CASE COMMENT REPORT

CASE NO. UDP-S24028

CASE:	UDP-S24028
MEETING DATE:	June 11, 2024
REQUEST:	Site Plan Level III Review: Multifamily Development with 22 Units with Modification To Increase The Allowed Building length in the Central Beach Regional Activity Center
APPLICANT:	Blue Skies Realty Investment, Inc.
AGENT:	Joseph Kaller, Kaller Architecture
PROJECT NAME:	Granada Condominiums
PROPERTY ADDRESS:	3003 Granada Street
ZONING DISTRICT:	A-1-A Beachfront Area District (ABA)
LAND USE:	Central Beach Regional Activity Center
COMMISSION DISTRICT:	2 – Steven Glassman
NEIGHBORHOOD ASSOCIATION:	Central Beach Alliance HOA
CASE PLANNER:	Nancy Garcia

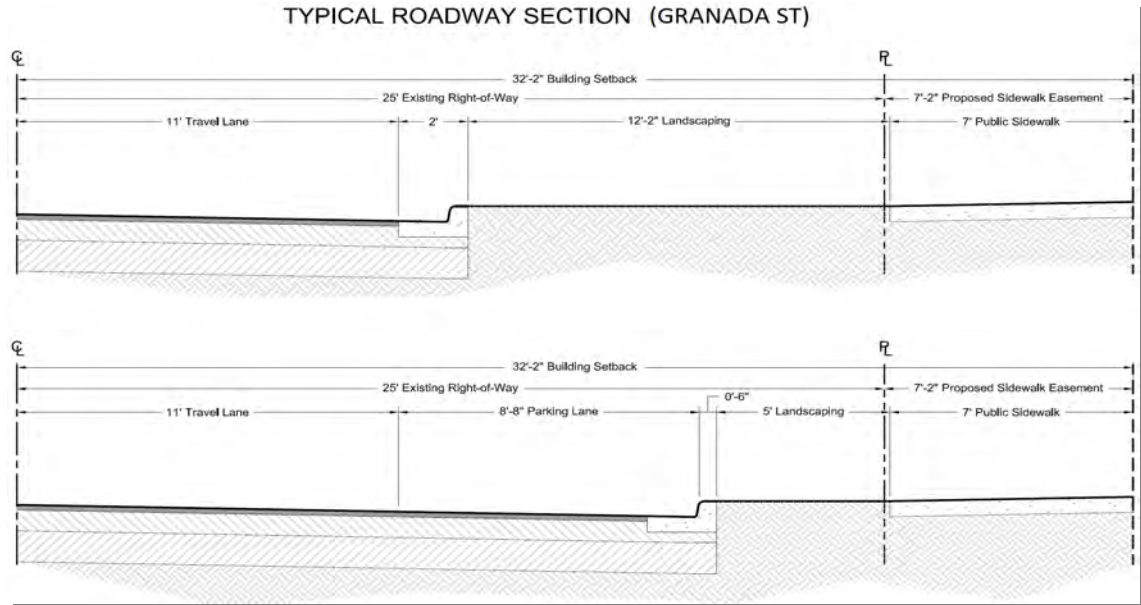
- g. The ground floor contains a significant amount of unusable green space, specifically along Birch Road. The image below demonstrates how the sidewalk should be shifted in towards the property to allow for a more visually appealing streetscape:
